Product Change Notification

NOTIFICATION NO.	ISSUE DATE	LAST BUY DATE	LAST SHIP DATE
EU-PCN-20220413-02	13.10.2022	---	---

SOP 4/5 pin type Photocoupler and Phototriac Coupler (36 models)
- please see the attached list for affected part numbers

1 . Transistor output

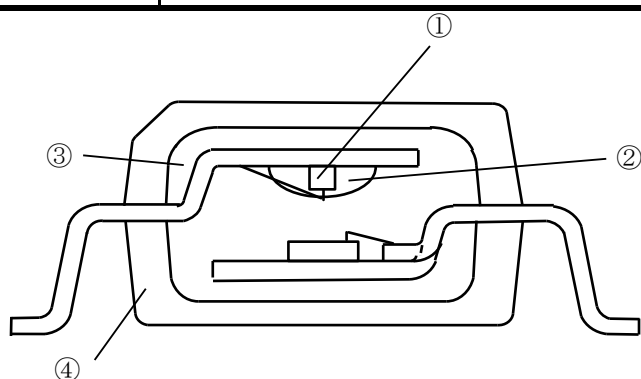
Addition of LED chip and resin.

2) Transistor / Triac output type : Withdrawal of addition of 1st mold resin.

Detail of modification (IC output type)

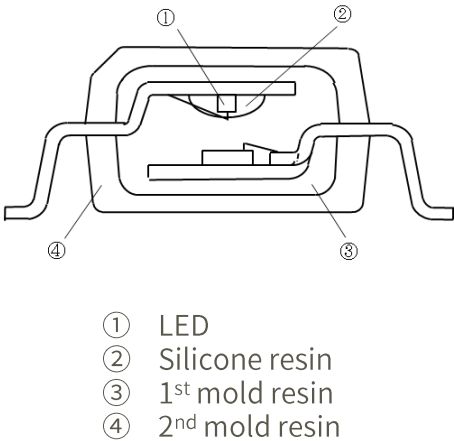
Reason of withdrawing from addition of LED chip (PC457L series)

⇒ We found that the value of current transfer ratio (CTR) was higher than expected when an additional light-emitting chip was used in the PC457L series.

If adopted, it will be necessary to change the upper limit of the specification, and we have determined that it may cause inconvenience to the customer's design, so we will remove the addition of the light-emitting chip. For the PC400 series and PC410LE series, we have judged that the same characteristics can be secured even after the addition of materials, so we will adopt them as planned.
